<b>Docket Number:</b>	08-AFC-09C
<b>Project Title:</b>	Palmdale Energy Project (Formerly Palmdale Hybrid Power Plant) - Compliance
<b>TN #:</b>	210171
<b>Document Title:</b>	Palmdale Energy LLC's Supplemental Response to California Energy Commission Staff Data Request 55 and 58
<b>Description:</b>	N/A
<b>Filer:</b>	Marie Fleming
<b>Organization:</b>	DayZen LLC
<b>Submitter Role:</b>	Applicant Representative
<b>Submission Date:</b>	2/5/2016 10:14:24 AM
<b>Docketed Date:</b>	2/5/2016

Attached is Palmdale Energy, LLC's supplemental responses to California Energy Commission Staff (Staff) Data Requests 55 and 58 for the Palmdale Energy Project (PEP) Petition For Amendment. For context the text of the Data Requests precedes the Data Responses.

**FIGURE 3.1a 230 kV Switchyard Single Line Drawing**

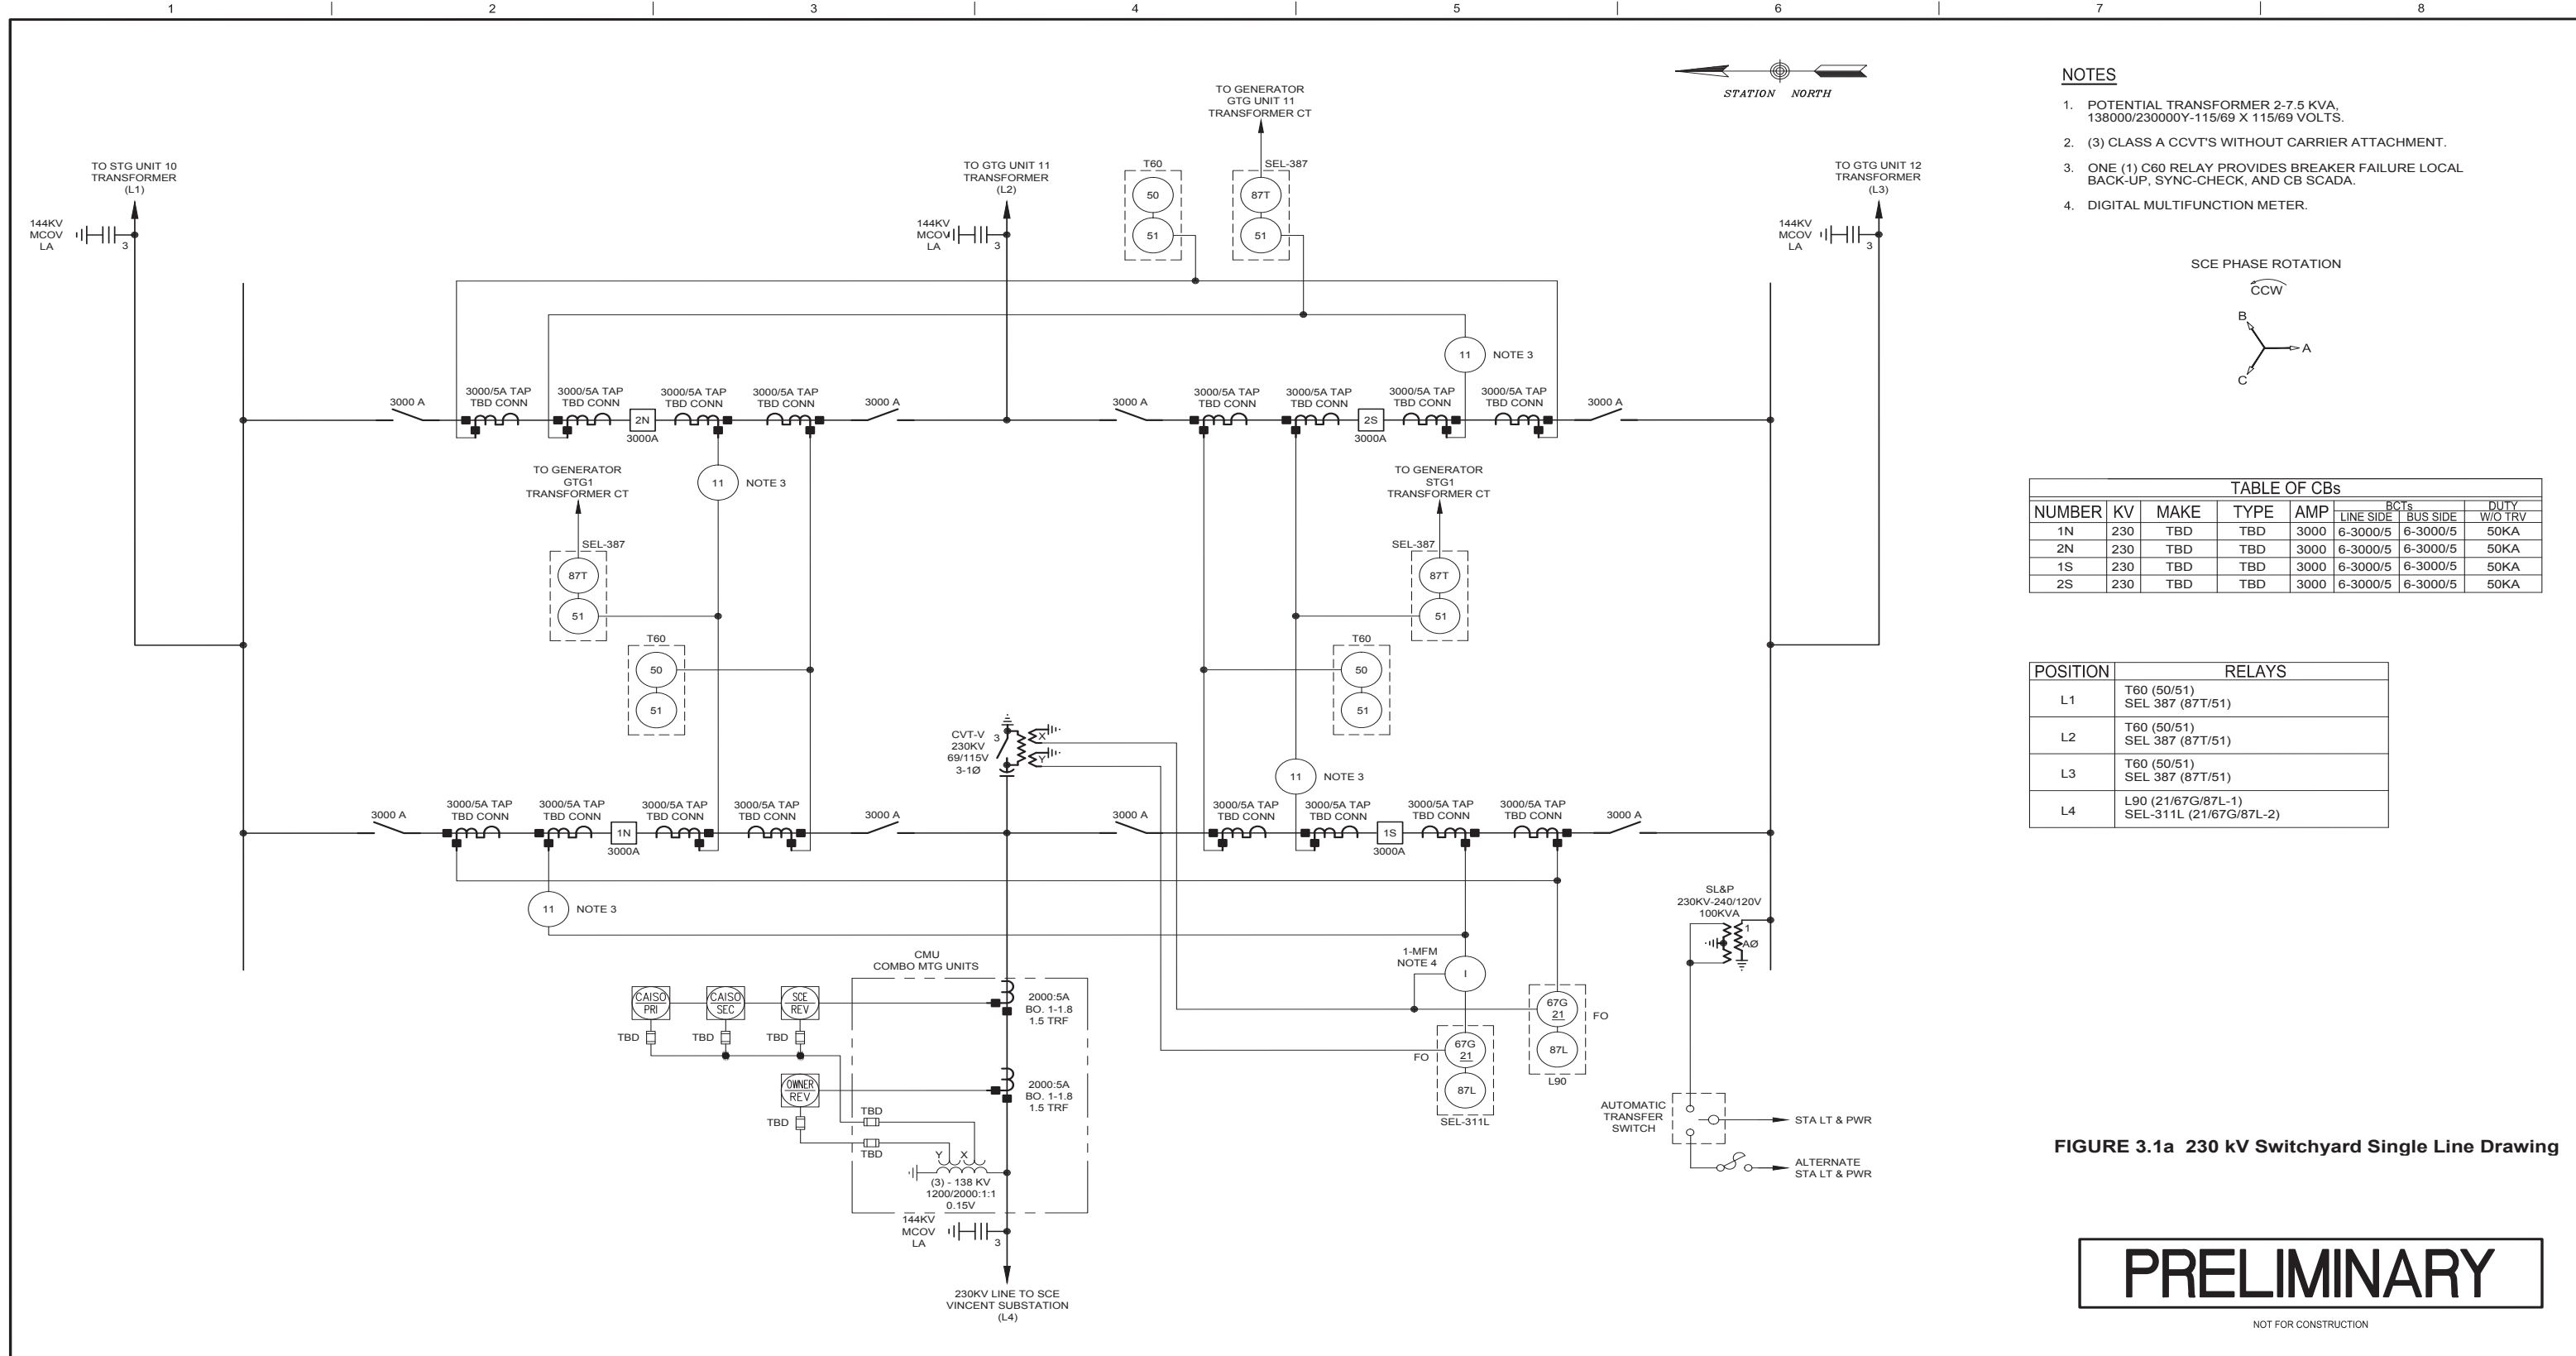
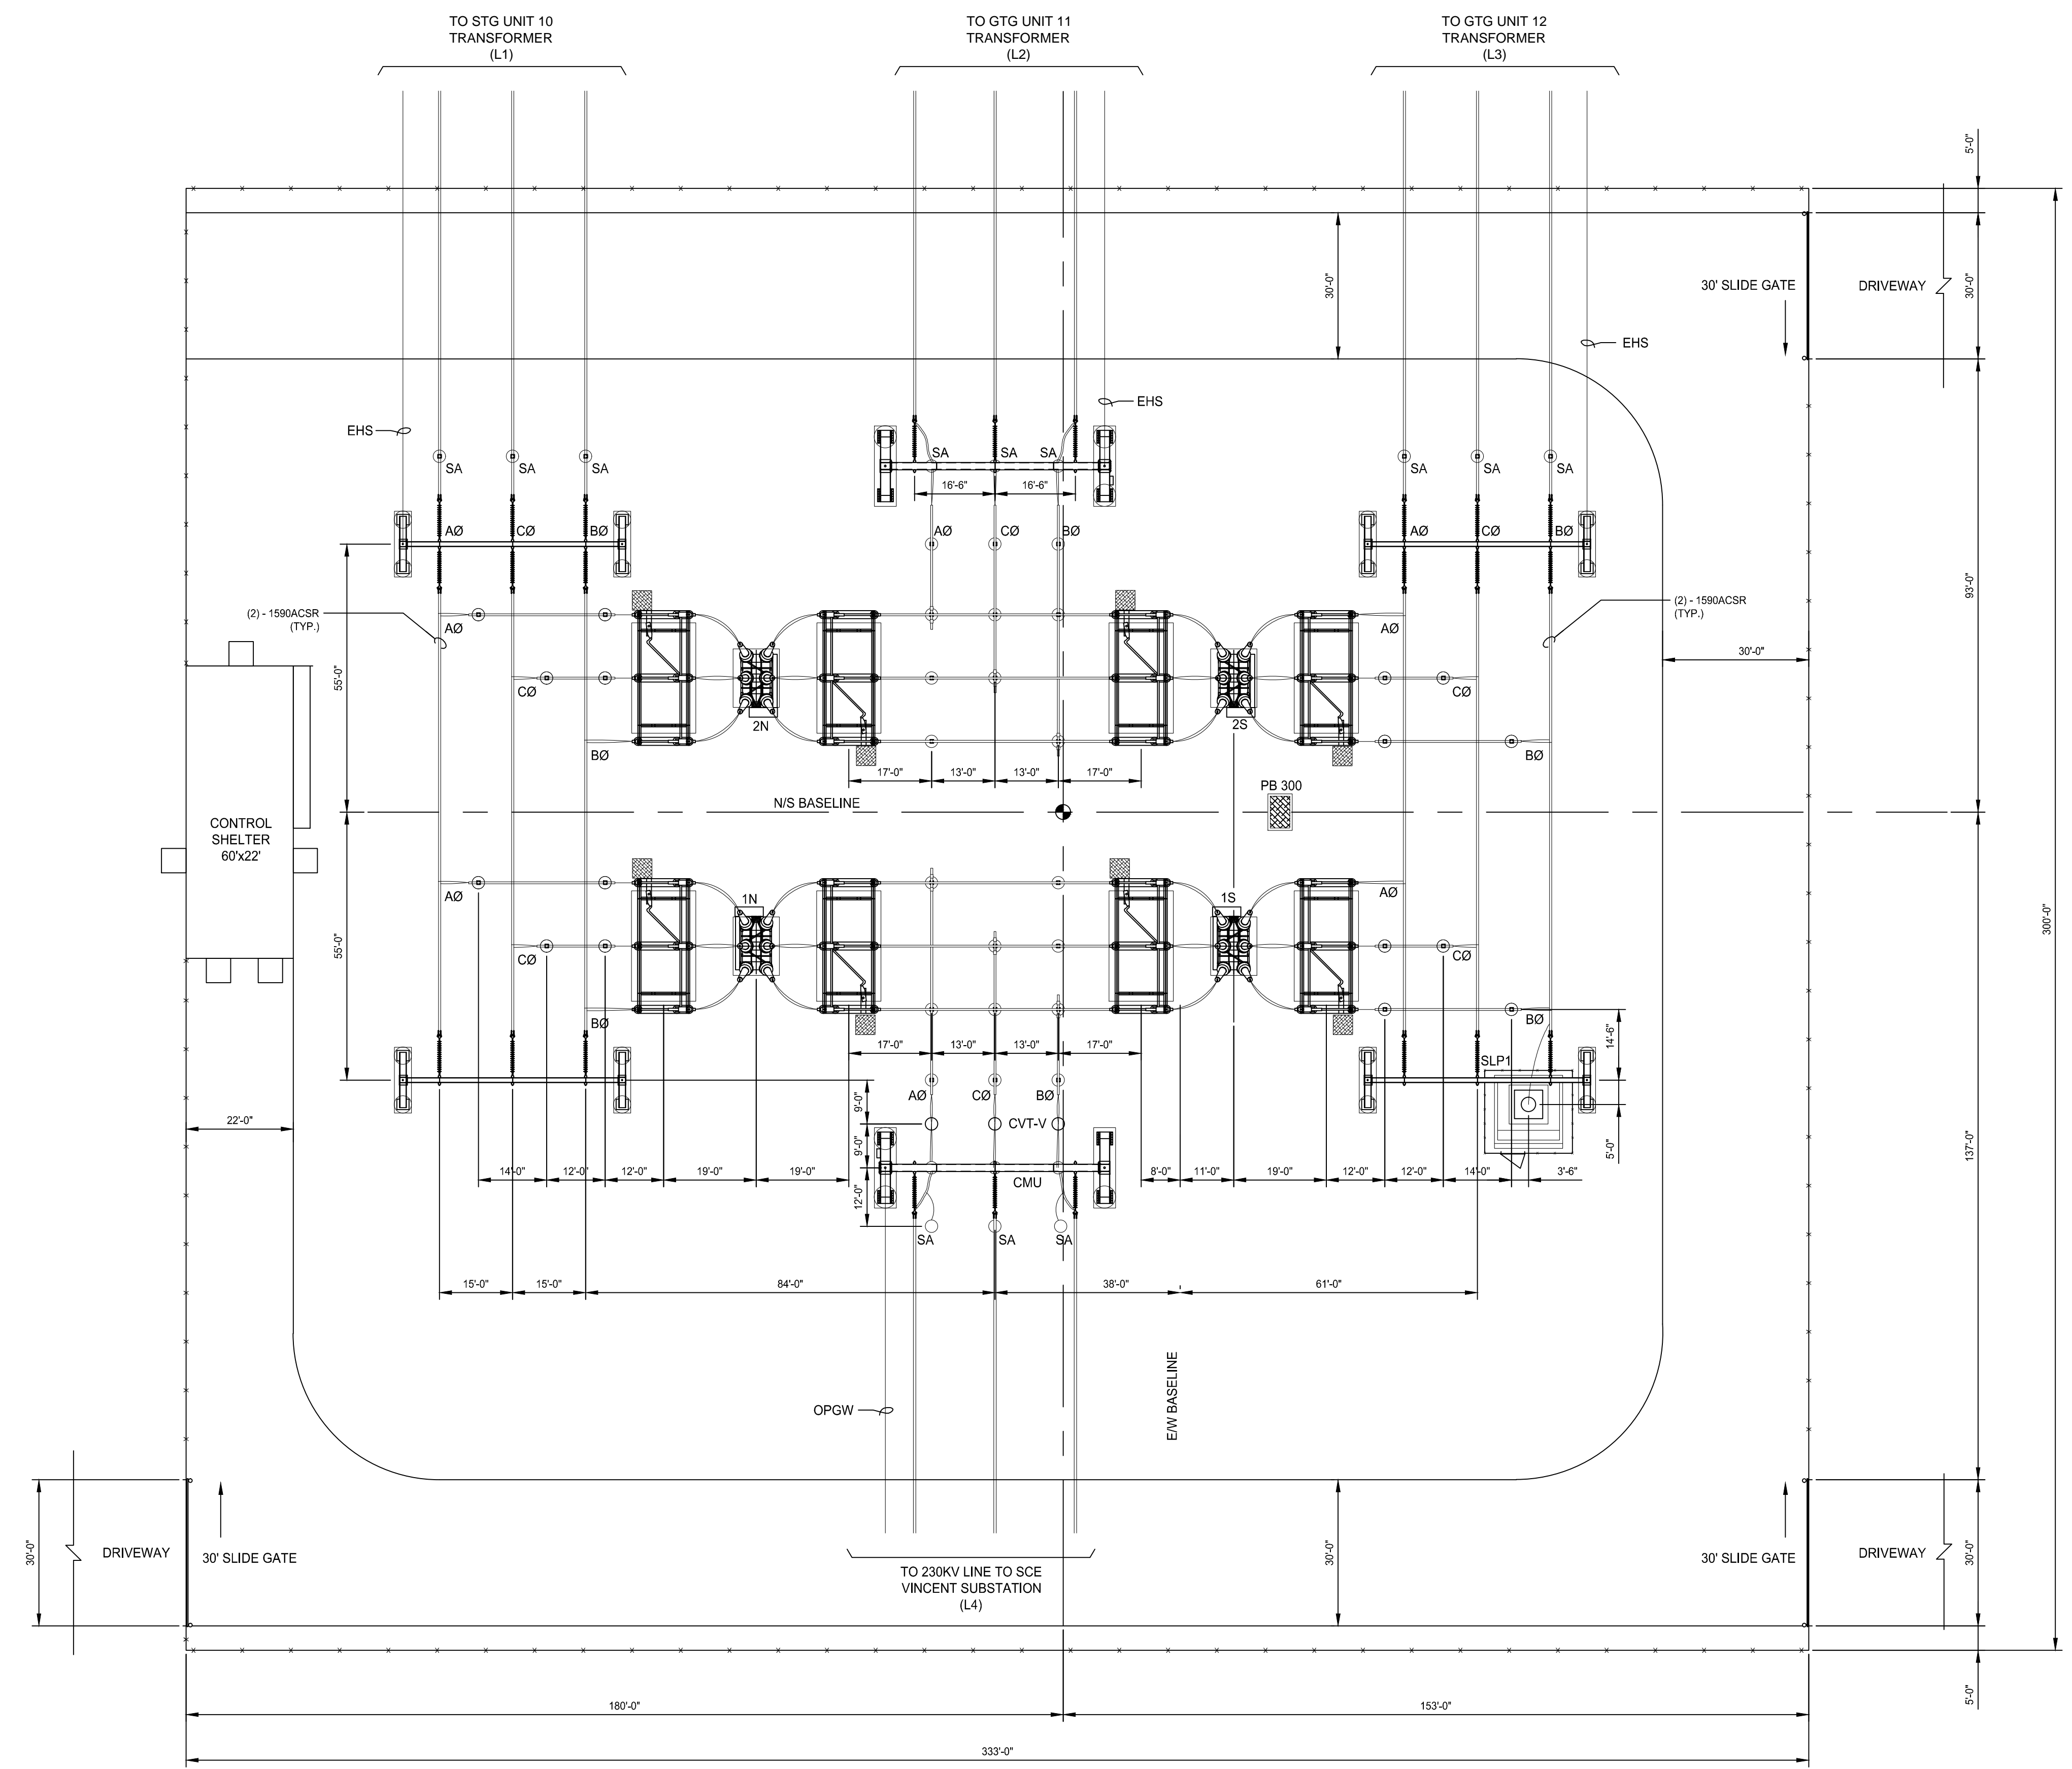
Resubmit Figure 3-1a and Figure 3-1b.

1. Show bay arrangement of the necessary equipment which is required to interconnect the project.
2. Provide ratings of the breakers, disconnect switches, relays, buses, and etc.

Figure 3-1a, the switchyard single line drawing, has been revised to show the ratings of breakers, disconnect switches, relays, buses, etc. Also, an arrangement drawing for the switchyard has been prepared. The arrangement drawing shows the arrangement of the breakers, disconnect switches, and take-off structures in the Project's 230 kV switchyard. The arrangement drawing is provided as Figure 3-1c, a new figure.
